SUBJECT: TECHNICAL SPECIFICATION CHANGES RELATING TO THE CYCLE 10 RELOAD

Re: Dresden Nuclear Power Station, Unit No. 2

Amendment No. 84
License No. DPR-19

ATTACHMENT TO LICENSE AMENDMENT NO. 84

Figure 3.5-1
 (Sheet 2 of 8)

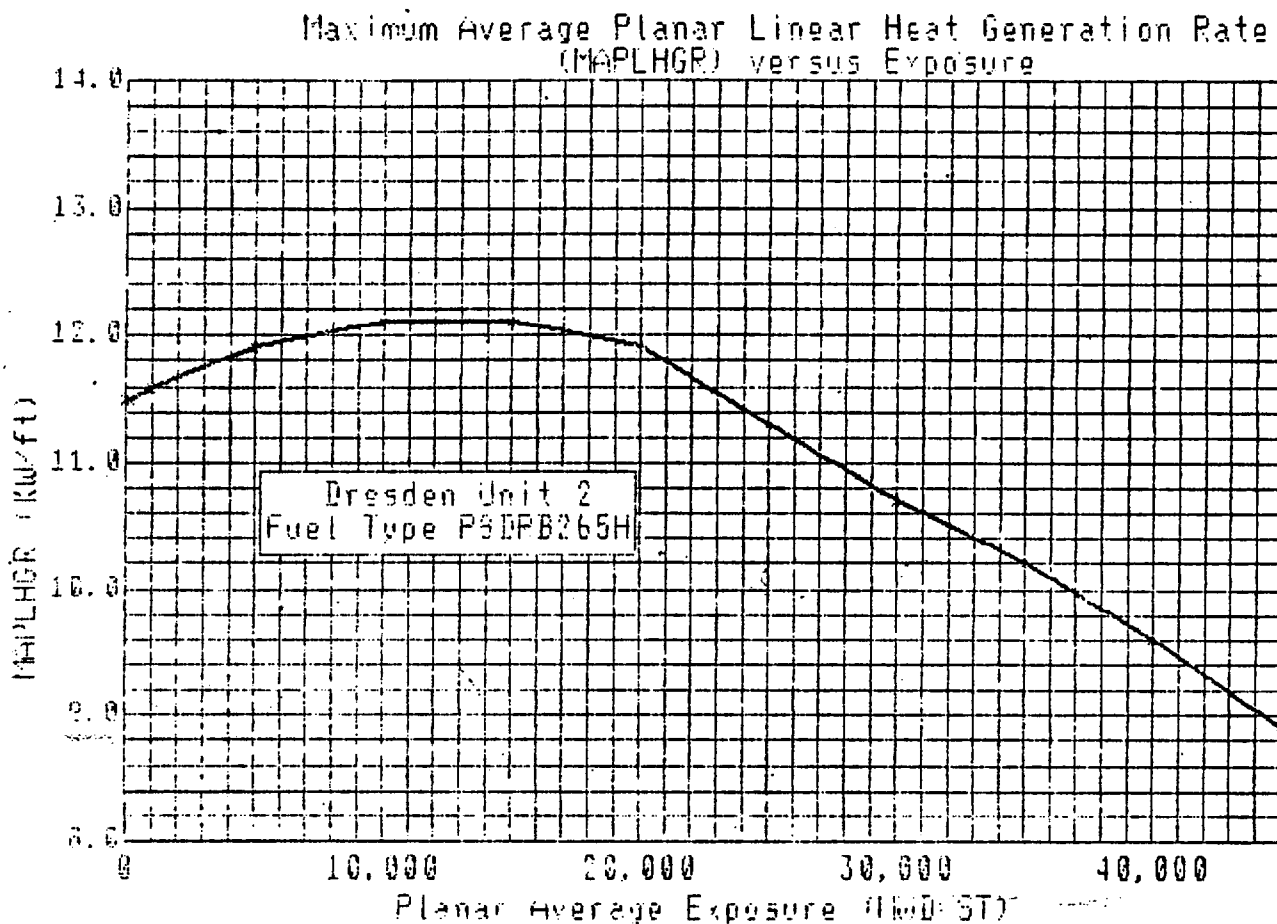
The licensee is also proposing to change the GE P8DRB265H fuel type burnup limit of the MAPLHGR curve to 45,000 MWD/ST. Although this fuel type is not expected to reach this burnup during Cycle 10, the licensee is proposing a change now to preclude a separate submittal and NRC review at a later date.

Planar Average Exposure (MWD/ST)	MAPLHGR (KW/Ft)
200	11.5
1,000	11.6
5,000	11.9
10,000	12.1
15,000	12.1
20,000	11.9
25,000	11.3
30,000	10.7
35,000	10.2
40,000	9.6
45,000	8.9

Figure 3.5-1
(Sheet 7 of 8)

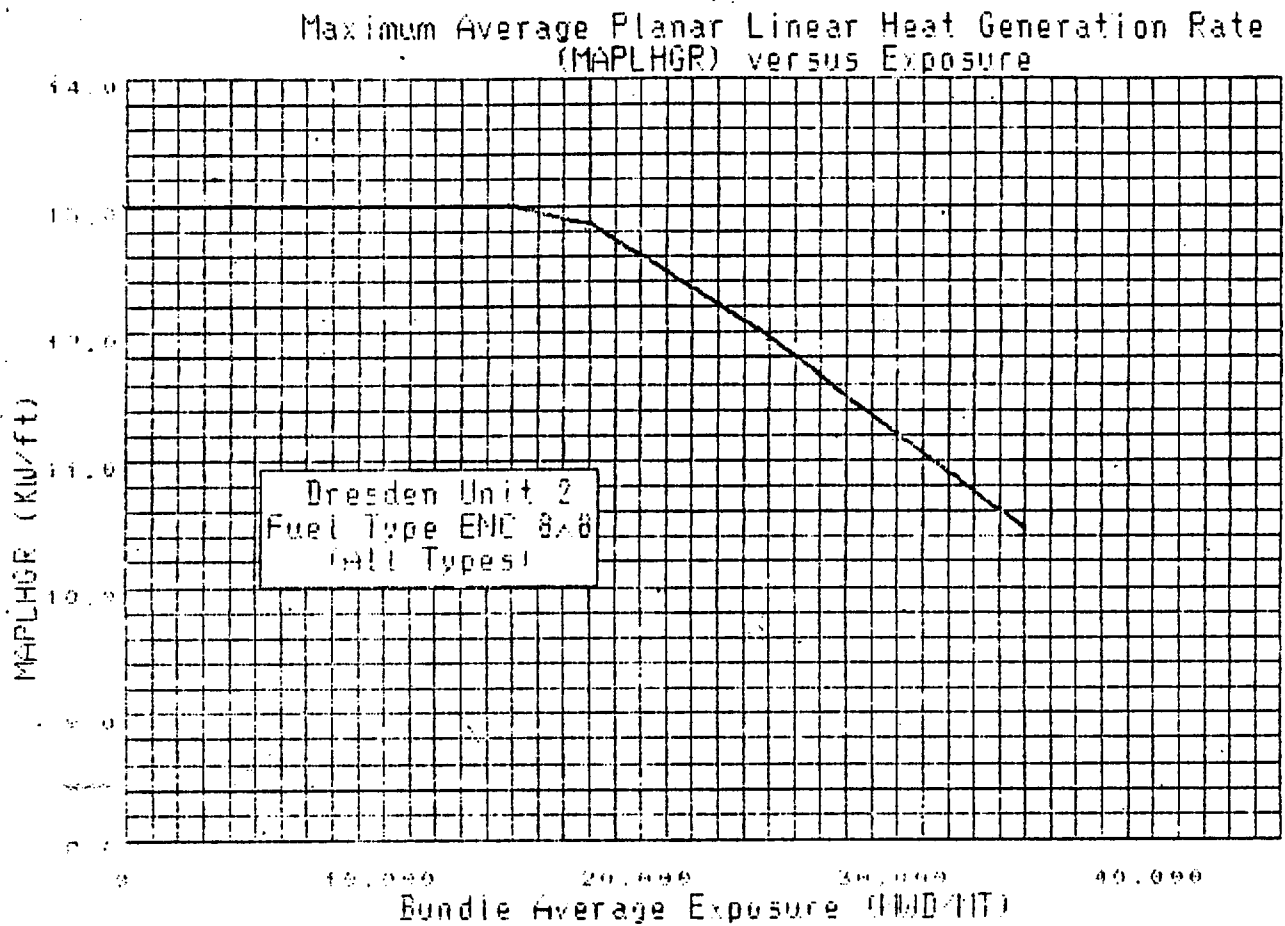
Specifically related to the reload fuel, the licensee requested extension of the maximum average planar linear heat generation rate (MAPLHGR) curves for 8 x 8 and 9 x 9 (Lead Test Assembly) (LTA) fuel types and for GE P8DRB265H fuel type and deletion of the MAPLHGR curve for GE fuel type P8DRB239 which has never been used at Dresden and is not expected to be in the future.

Bundle Average Exposure (MWD/MTU)	MAPLHGR (KW/Ft)
0	13.0
15,000	13.0
18,000	12.85
20,000	12.60
25,000	11.95
30,000	11.20
35,000	10.45

MCPR Limit For Automatic Flow Control
 Figure 3.5-2
 (Sheet 2 of 2)

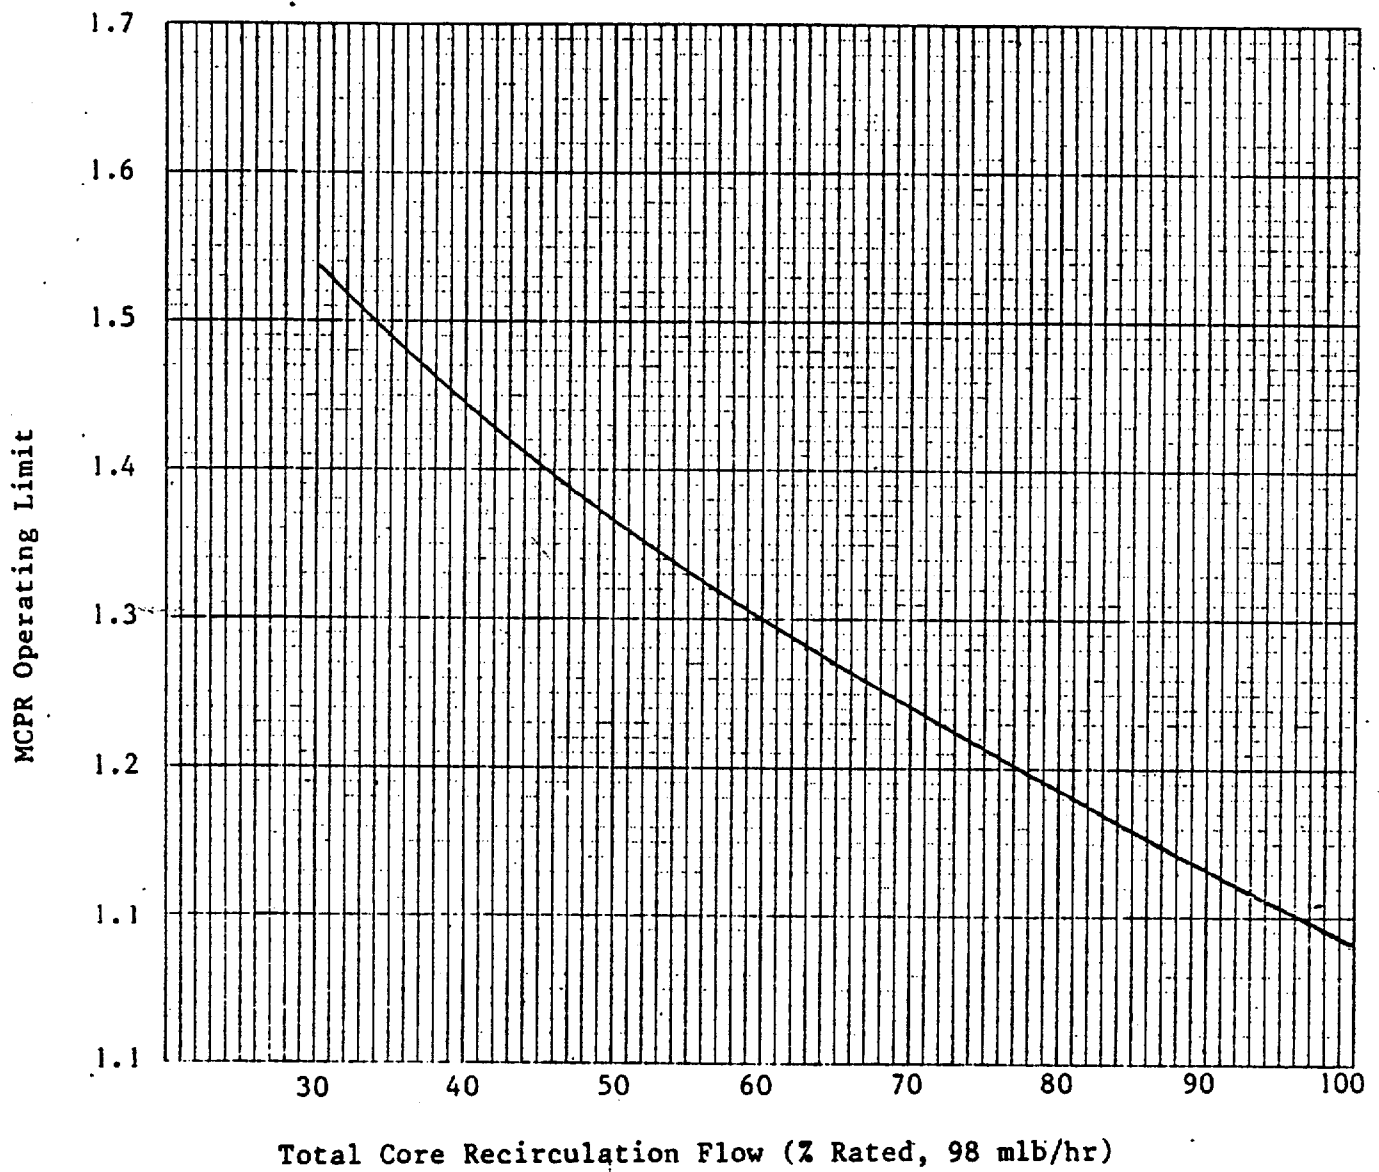
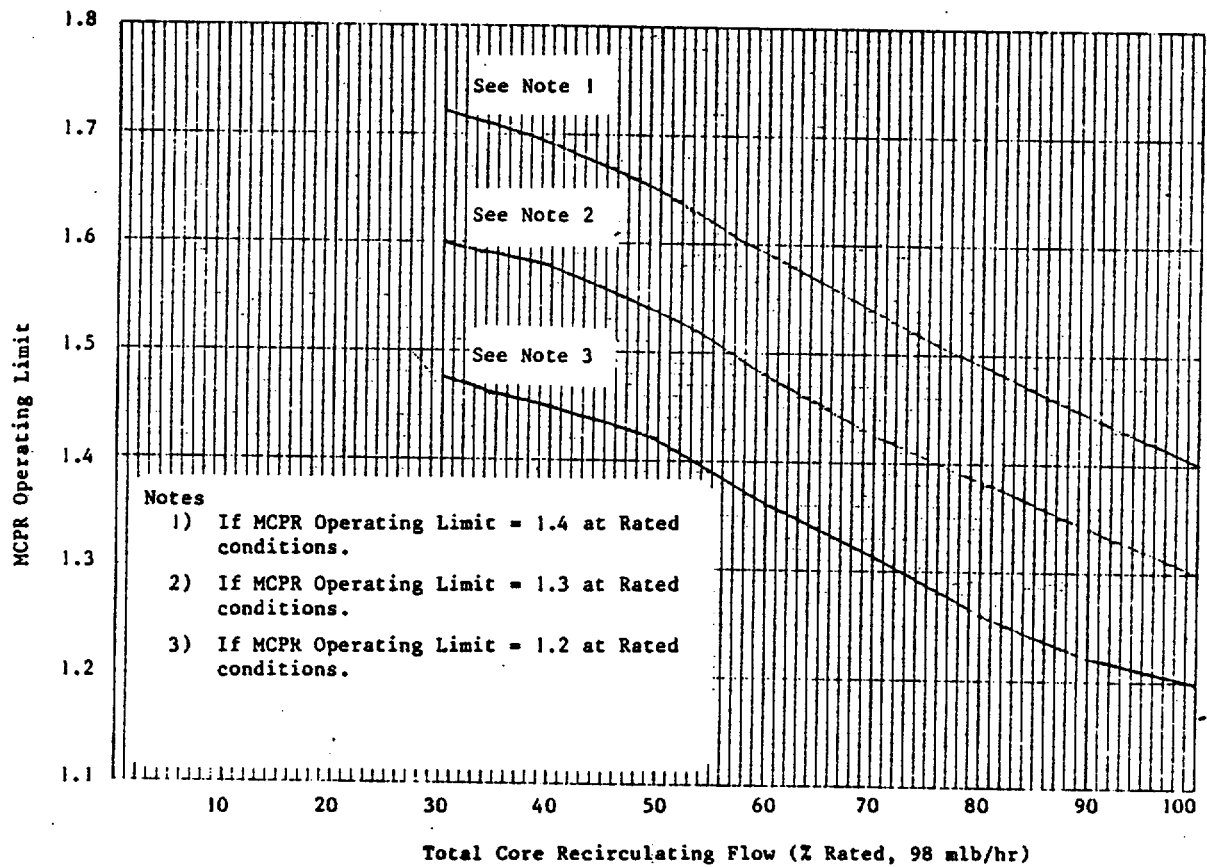
For core flows less than rated, the MCPR Operating Limit established in the specification is adjusted to provide protection of the MCPR Safety Limit in the event of an uncontrolled recirculation flow increase to the physical limit of pump flow. This protection is provided for manual and automatic flow control by choosing the MCPR operating limit as the value from Figure 3.5-2 Sheet 1 or the rated core flow value, whichever is greater. For Automatic Flow Control, in addition to protecting the MCPR Safety Limit during the flow

run-up event, protection is provided against violating the rated flow MCPR Operating Limit during an automatic flow increase to rated core flow. This protection is provided by the reduced flow MCPR limits shown in Figure 3.5-2 Sheet 2 where the curve corresponding to the current rated flow MCPR limit is used (linear interpolation between the MCPR limit lines depicted is permissible). Therefore, for Automatic Flow Control, the MCPR Operating Limit is chosen as the value from Figure 3.5-2 Sheet 1, Sheet 2 or the rated flow value, whichever is greatest. It should be noted that if the rated flow MCPR Limit must be increased due to degradation of control rod scram times during the current cycle, the new value of the rated flow MCPR limit is applied when using Figure 3.5-2 Sheet 2.

1. Manual Flow Control - the MCPR Operating Limit shall be the value from Figure 3.5-2 Sheet 1 or the above rated core flow value, whichever is greater.
2. Automatic Flow Control - the MCPR Operating Limit shall be the value from Figure 3.5-2 Sheet 1, Sheet 2 or the above rated core flow value, whichever is greatest.
